Re: Indian Point Unit No. 3
Docket No. 50-286
NL-03-140

Subject: **Reply to Request for Additional Information
Regarding NRC Order EA-03-009 Relaxation Request (TAC MB8163)**

**RESPONSE TO NRC QUESTIONS REGARDING
NRC ORDER EA-03-009 RELAXATION REQUEST
PERTAINING TO INSPECTION OF THREADED REGION OF NOZZLES**

**NRC ORDER EA-03-009 RELAXATION REQUEST, REVISION 1
PERTAINING TO INSPECTION OF THREADED REGION OF NOZZLES**

FIGURE 1
IP3 PENETRATION NOZZLES
HEAD NOZZLE WELD AREA

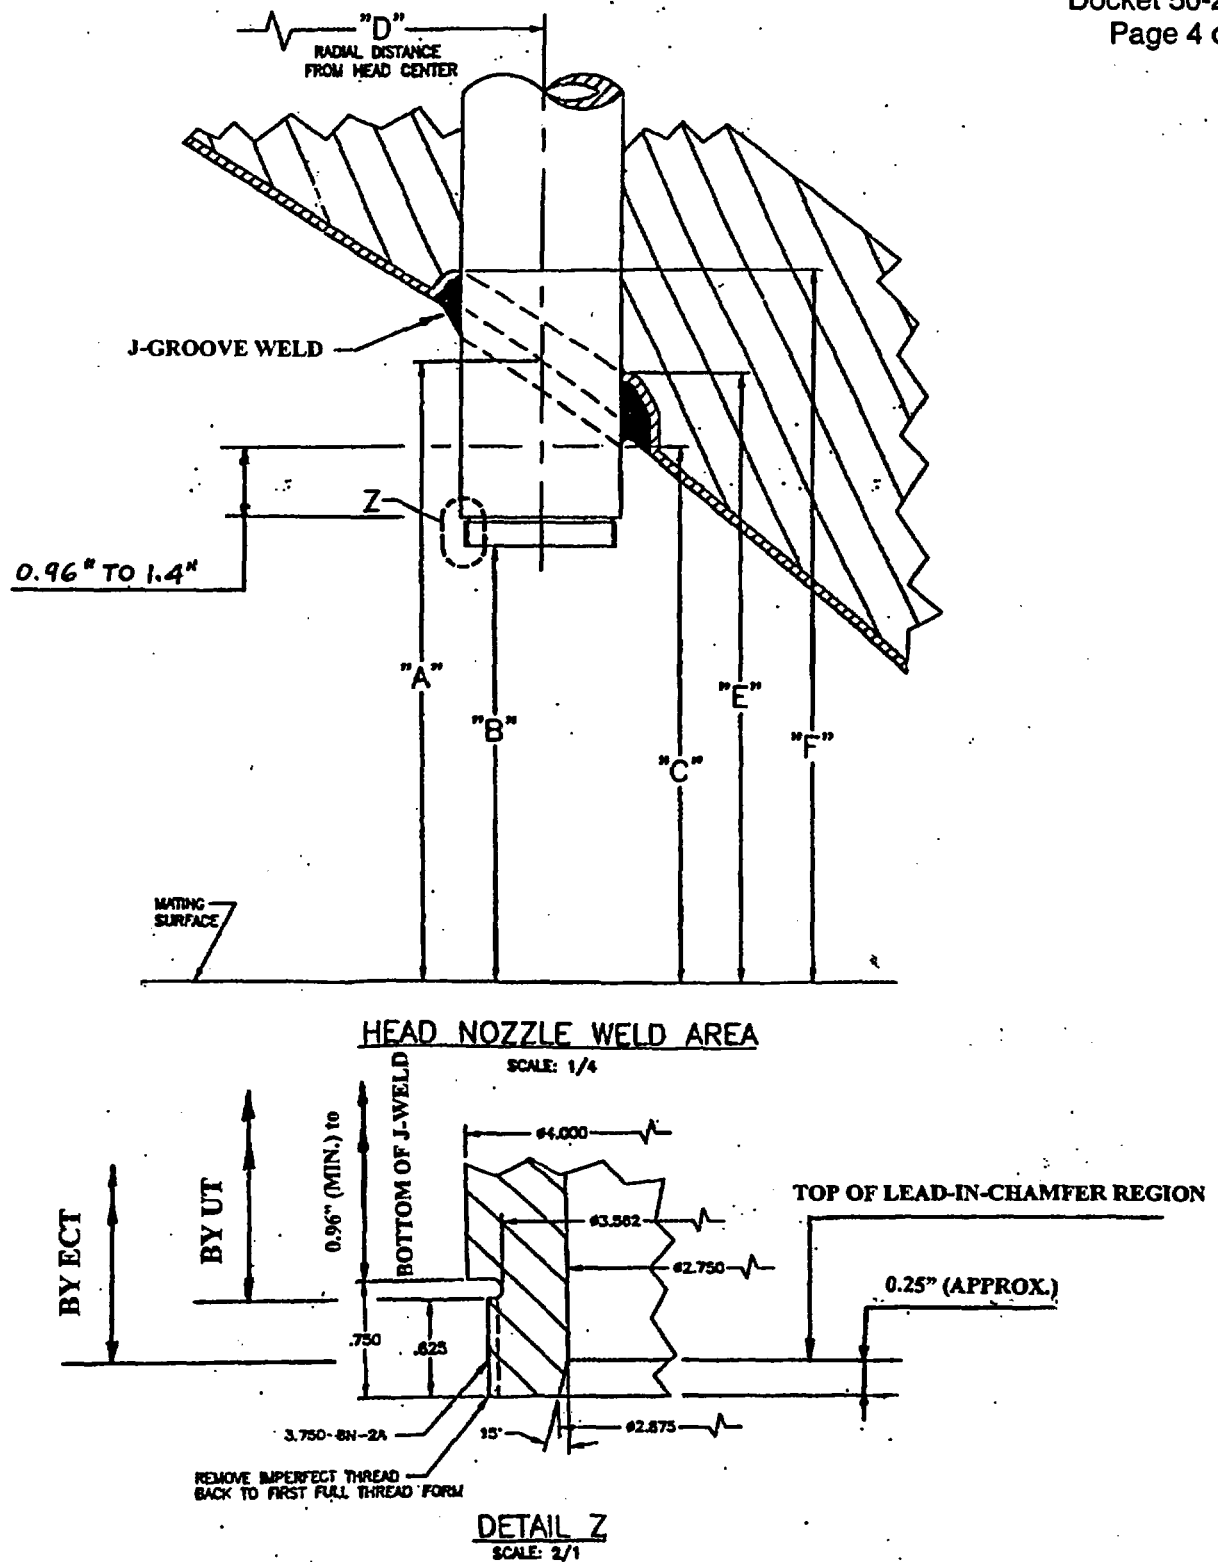
Provide the applicable technical data (i.e., operating stress levels, crack growth analysis, hoop stresses, etc) which supports the conclusion that the area in the threaded region is insignificant.

Identify the particular NDE methods that would be utilized, and provide the justification why this additional NDE would not be proposed / performed as an alternative to the requirements in the Order.

The structural evaluation for Indian Point 3 consists of a crack growth analysis using the methods of MRP-55 for crack growth caused by primary water stress corrosion cracking at a head temperature of 592 degrees F. The nozzle is an open-ended tube so that the operating pressure and temperature are essentially the same at both the inside and outside surface of the tube. Therefore the operating stress levels are negligible for this case. For purposes of this analysis, a conservatively high hoop stress of 30 ksi is assumed. An initial hypothetical flaw is assumed to exist with a worst-case orientation (axial) and flaw growth occurs in a single direction toward the J-groove weld. Because the location of the hypothetical flaw is in the threaded region, at least 0.96 inches from the J-groove weld, the weld residual stresses are also negligible. The analysis concludes that crack growth in a 4-year operating period is approximately 0.54 inches, well within the minimum dimension of 0.96 inches to the closest point of the J-groove weld. Refer to Figure 1 in the relaxation request for the location of these dimensions on the penetration nozzles.

case, non-destructive examination of the RPV head penetration nozzles is required by the Order. However, the bottom 0.75 inches of the nozzles are designed with a threaded region to accommodate the installation of guide funnels (Figure 1). Based on experience gained during the inspection in 3R12, meaningful ultrasonic test data cannot be obtained in this region, due to dispersion of the ultrasonic test signal. Therefore, the relaxation request is needed to support a non-destructive examination of the RPV nozzles based on use of ultrasonic test methods.

Entergy will perform ultrasonic testing of each RPV head penetration nozzle (i.e., nozzle base material) from two (2) inches above the J-groove weld and extending down the nozzle to the top of the threaded region, which is approximately 0.75 inches above the bottom of the nozzle.

The ultrasonic testing will extend from two (2) inches above the J-groove weld to the top of the threaded region at the bottom of the penetration nozzle. The axial dimension from the bottom portion of the J-weld (at the lowest point) to the top of the threaded region ranges from 0.96 inches to 1.4 inches, depending on the radial location of the nozzle. This coverage provides an acceptable level of quality and safety because:

- A conservative analysis for the IP3 nozzles shows that the crack growth over a 4-year operating period would be approximately 0.54 inches. An undetected crack at the most limiting location (at the top end of the threaded region) would have to propagate 0.96 inches in the most limiting nozzles in order to reach the J-groove weld. Since the inspection frequency for IP3 would be at least every other refueling outage (nominally every 4 years) for a moderate category classification, an undetected crack in the threaded region would not propagate to the J-groove weld prior to the next inspection interval. The inspection program with a high category classification would require a more frequent inspection, every refueling outage.
